APPLICATION FOR PERMIT TO DRILL				5. MINERAL LEASE NO: UTU-02278	6. SURFACE: State
1A. TYPE OF WORK: DRILL <input checked="" type="checkbox"/> REENTER <input type="checkbox"/> DEEPEN <input type="checkbox"/>				7. IF INDIAN, ALLOTTEE OR TRIBE NAME:

2. NAME OF OPERATOR: KERR MCGEE OIL & GAS ONSHORE L.P.				9. WELL NAME and NUMBER: NBU 1021-20K	
3. ADDRESS OF OPERATOR: 1368 S 1200 E CITY VERNAL STATE UT ZIP 84078			PHONE NUMBER: (435) 781-7024	10. FIELD AND POOL, OR WILDCAT: NATURAL BUTTES

Application for Permit to Drill

Statement of Basis

FIGURE #1

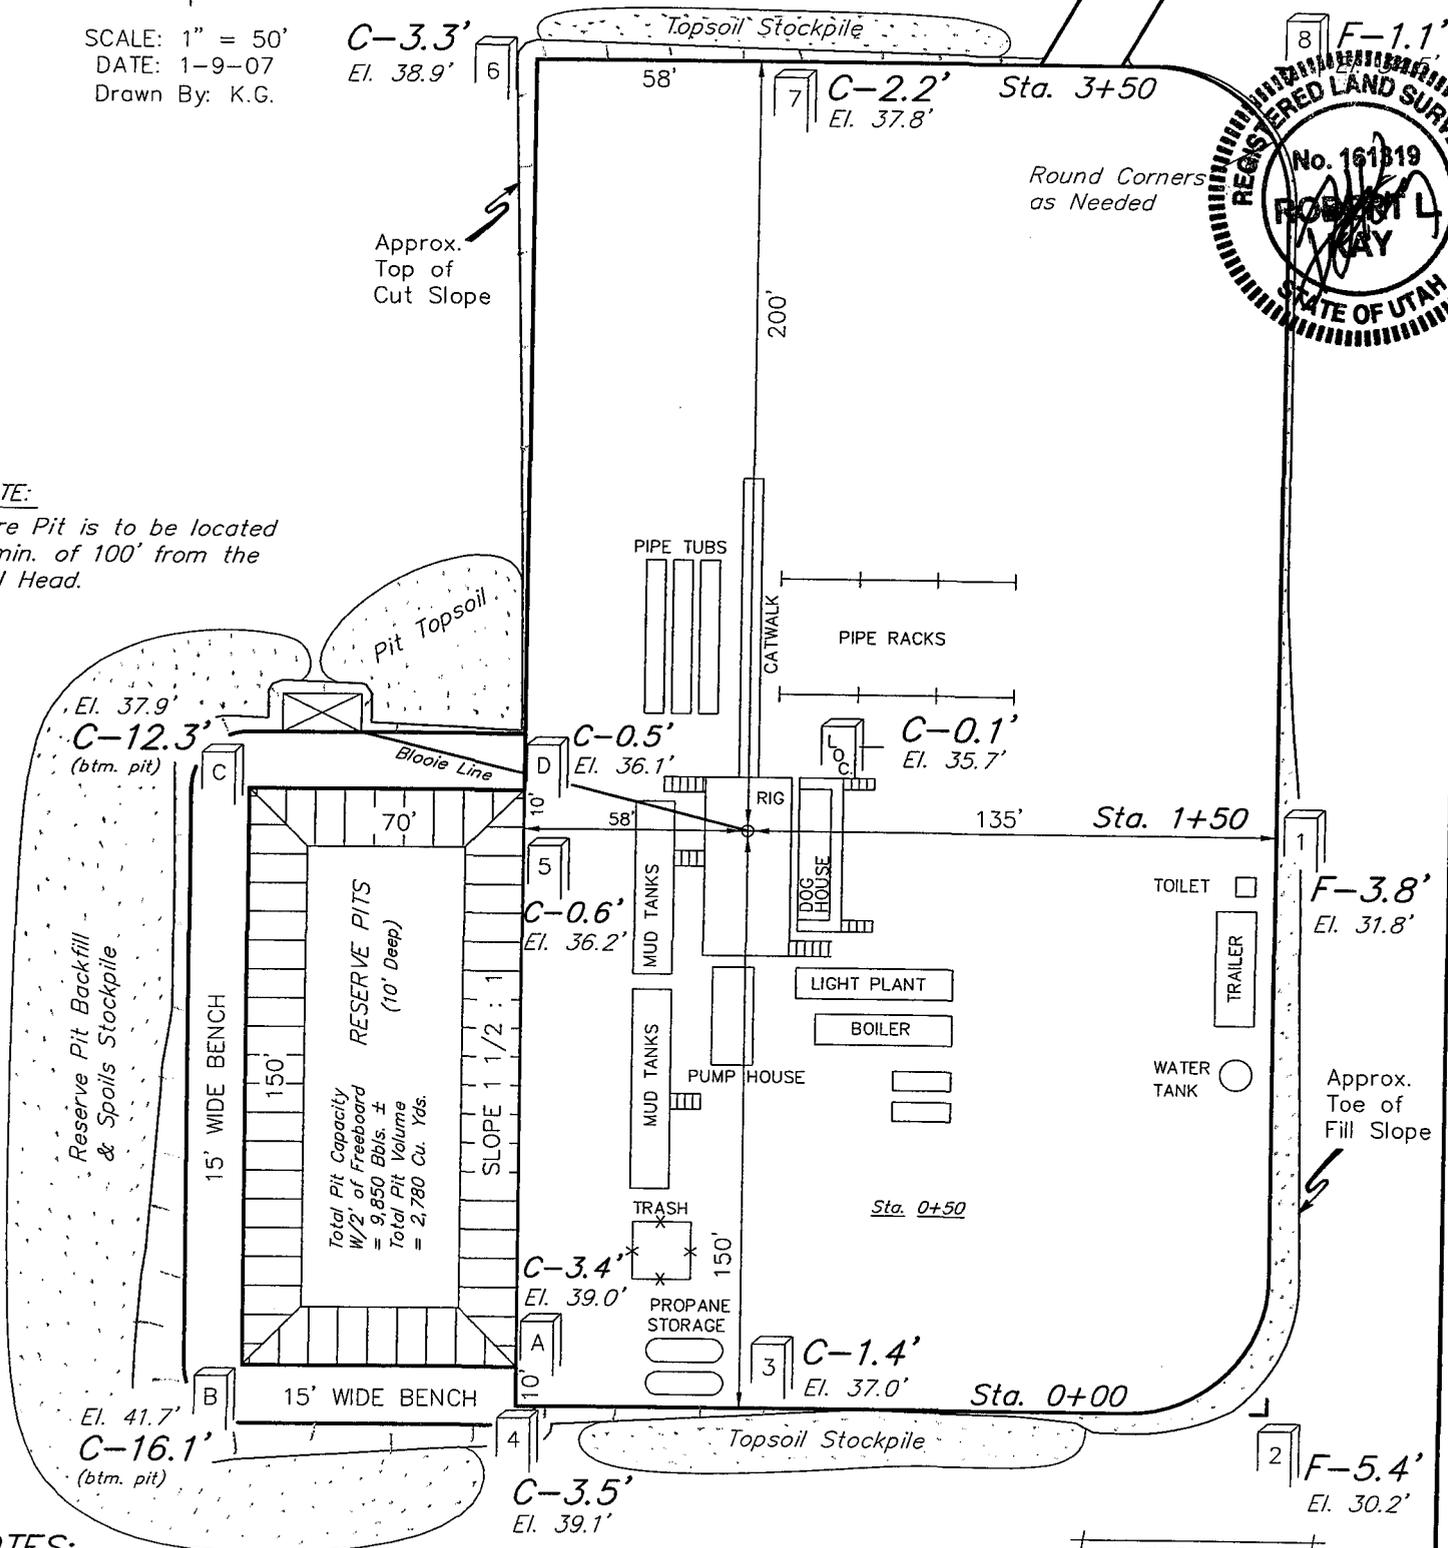
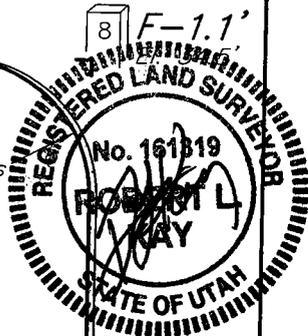
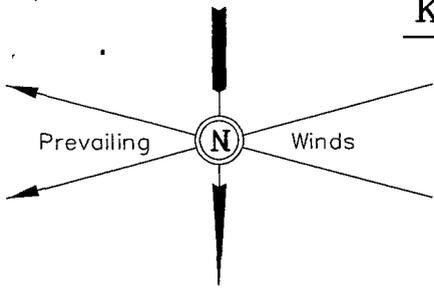
The proposed gas well is on the east side of the bottom of Cottonwood Wash. It begins along the edge of the slope with the pad extending to near the bottom of Cottonwood Wash on the southwest end. The incised bottom of the Wash is about 3 feet deep and runs straight in this area and any high flows should not endanger the pad. The pad also has a 1.1-foot fill in this area to further keep any flow off the pad. A side drainage from the east slope needs to be diverted around the east and north end of the reserve pit. A new Location Layout Sheet (Figure 1) will be submitted to show this.

The proposed gas well is on the east side of the bottom of Cottonwood Wash. It begins along the edge of the slope with the pad extending to near the bottom of Cottonwood Wash on the southwest end. The incised bottom of the Wash is about 3 feet deep and runs straight in this area and any high flows should not endanger the pad. The pad also has a 1.1-foot fill in this area to further keep any flow off the pad. A side drainage from the east slope needs to be diverted around the east and north end of the reserve pit. A new Location Layout Sheet (Figure 1) will be submitted to show this.

A diversion needs to be constructed above the spoils of the reserve pit to the north and west around the pit.

FIGURE #1

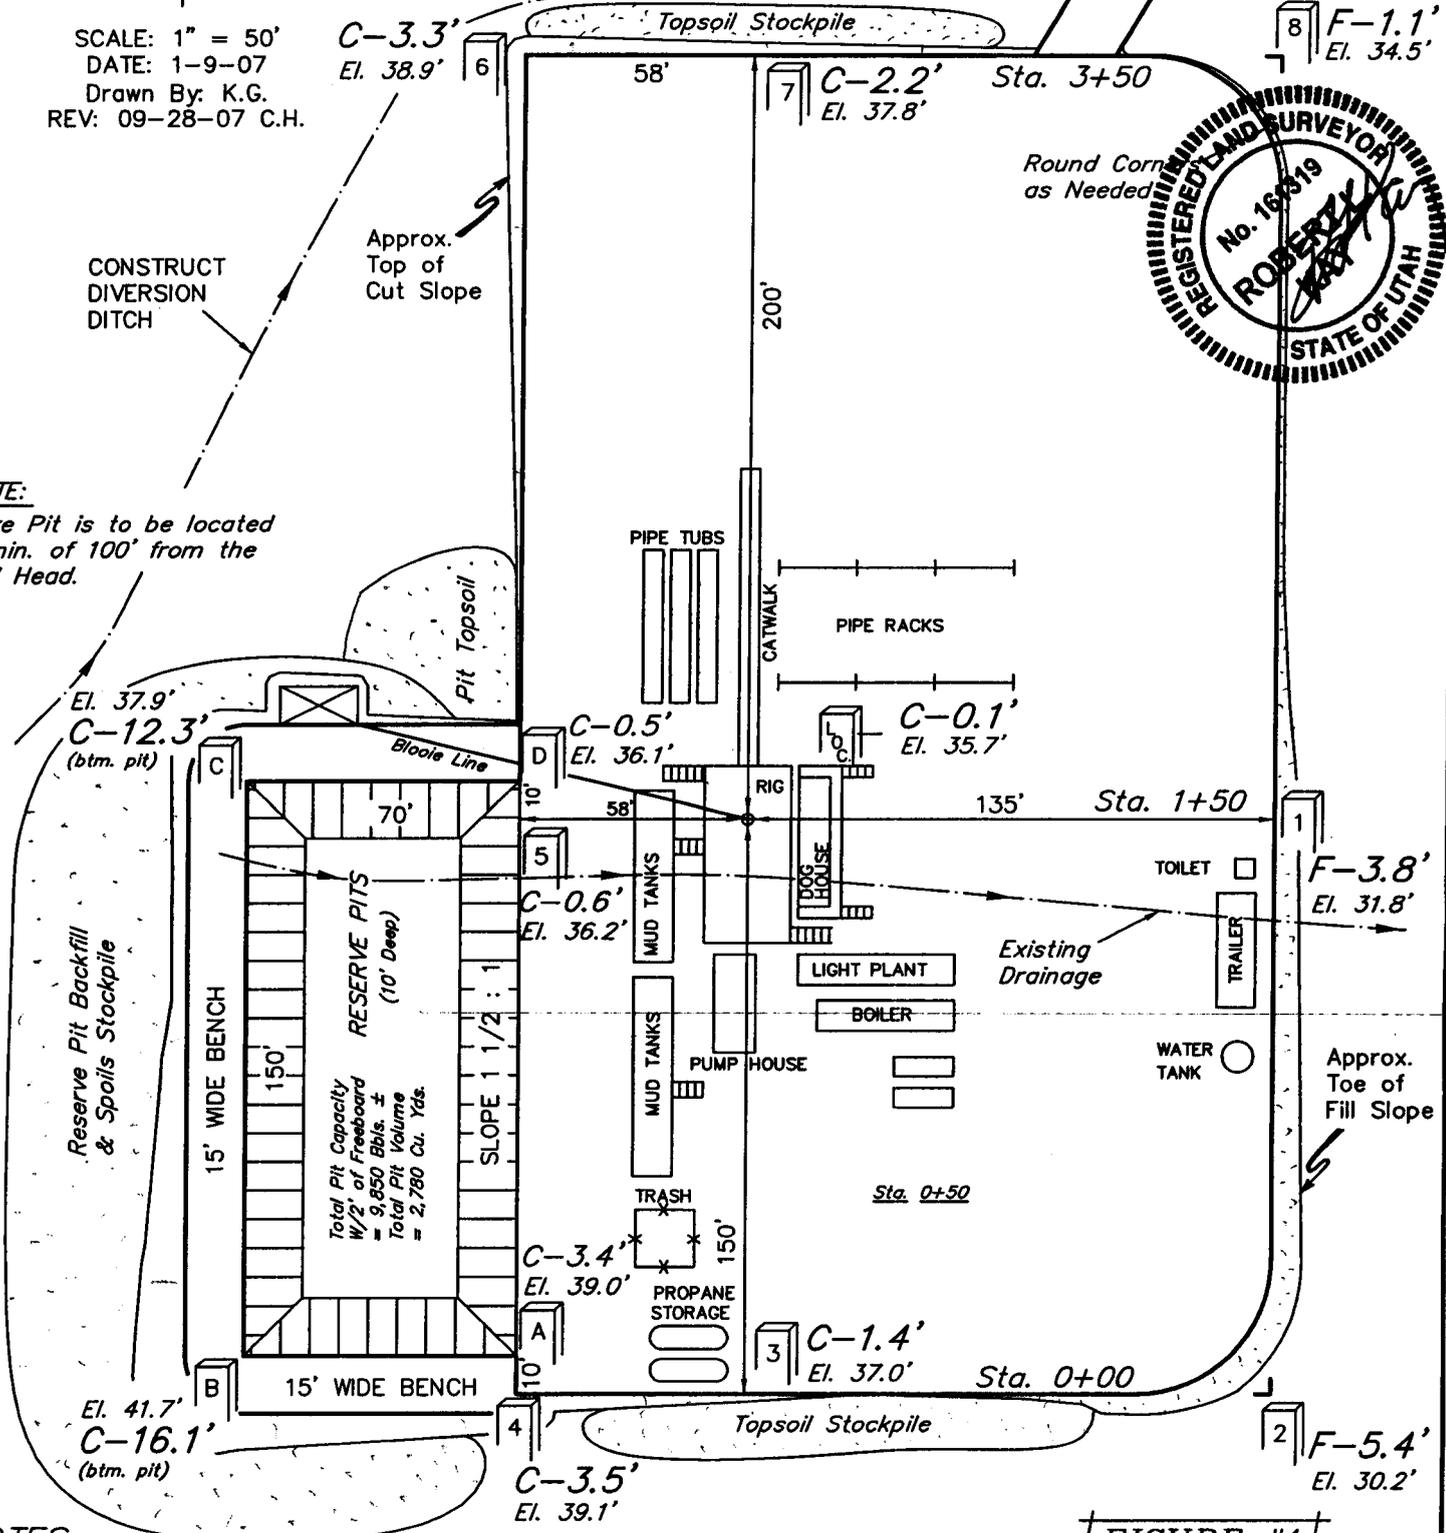
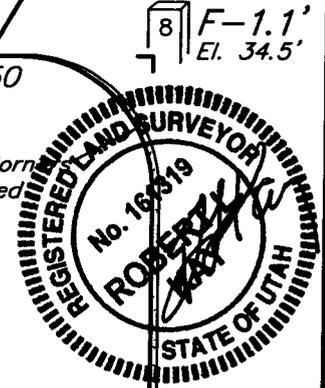
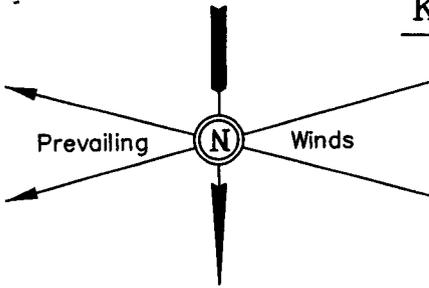
AN ON-SITE INSPECTION HAS BEEN PERFORMED ON 09/19/2007, WITH THE DIVISION OF OIL, GAS AND MINING AND SITLA. IT WAS DECIDED TO CHANGE THE LOCATION LAYOUT TO SHOW DIVERSION DITCH AROUND CORNER "6".

PLEASE REFER TO THE ATTACHED REVISED LOCATION LAYOUT.

CONSTRUCT DIVERSION DITCH
